Detailed Site Plan
Departure from Design Standards
Alternative Compliance
Dash In at Marlboro Pike #1552

DSP-21009
DDS-687
AC-21022

STAFF REPORT

SUBJECT: Detailed Site Plan DSP-21009
Departure from Design Standards DDS-687
Alternative Compliance AC-21022
Dash in at Marlboro Pike

Figure 1: Site Plan

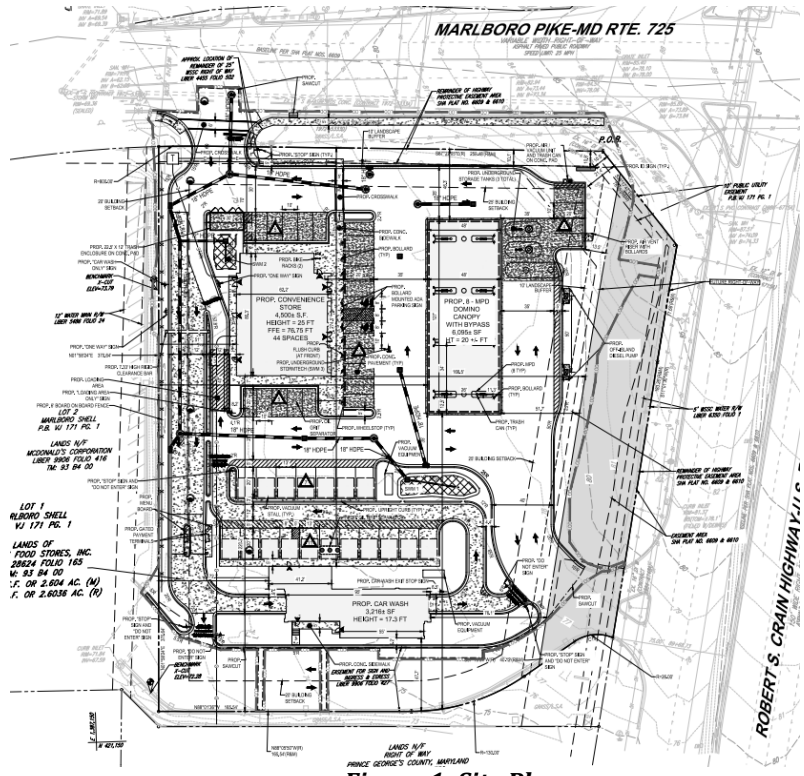
1. The bearing for the western property line shown on the DSP is inconsistent with the record plat.
2. The area of Lot 1 is not labeled on Sheet 4 of the plan set.

- a. Revise the bearing for the western property line shown on the DSP to match the record plat.
 - b. Revise the height of the proposed freestanding pylon sign to 25 feet or revise the sign detail to reflect that there are three fuel types being proposed to meet the 50-foot height requirement.

- c. Revise the sign legend to correspond to the signs on the site plan. Provide the same labeling convention for both the legend and the plan.
 - d. Label the area of Lot 1 on Sheet 4 of the DSP in square feet and acres.

- g. Provide the exact dimensions of the buildings on the site plan.

- h. Add the street connection width for MD 725 (Marlboro Pike) to the site plan.
- i. Revise the landscape plan to conform to Section 4.3 by removing one parking space to the east of the food and beverage store, widening the planting islands five feet, and adding a shade tree to each island.

1. Prior to certification of the detailed site plan, the following revisions shall be made to the plan:
 - a. Revise the bearing for the western property line shown on the detailed site plan to match the record plat.
 - b. Label the area of Lot 1 on Sheet 4 of the detailed site plan in square feet and acres.
